RE: Additional Information Requested for License Amendment Request – License No.  
24-13365-01, Amendment 30

Attached is the additional information requested in regards to the Amendment 30  
application for License No. 24-13365-01.

**From:** George McCann [GMM@nrc.gov]  
**Sent:** Tuesday, July 24, 2007 9:20 AM  
**To:** Sheila Hecht  
**Cc:** gmccann1@ameritech.net; William Snell  
**Subject:** RELEASEE OF FORMER STORAGE BUILDING

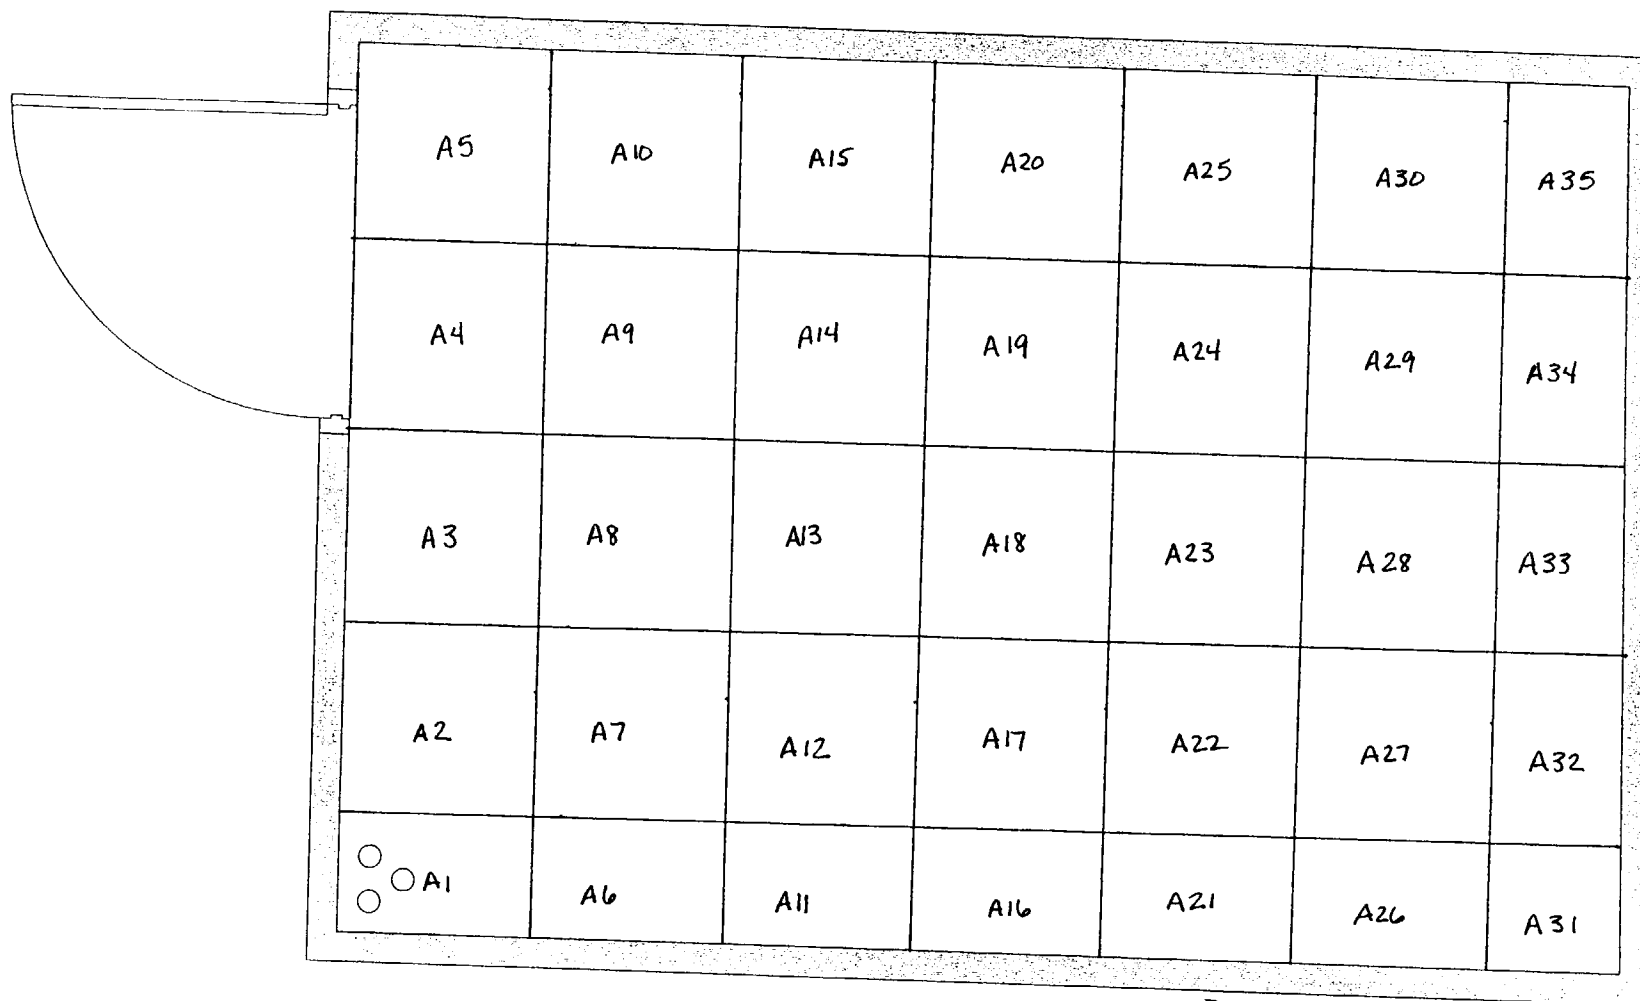
2) The liquid scintillation computer printouts for Rooms 601, 602, 603 and the Entrance Room are all so light they are unreadable. We need copies we can read.

3. The liquid scintillation computer printouts for Rooms 601, 602, 603, and the Entrance Room are all so light they are unreadable. We need copies we can read.

Please see attachment (3).
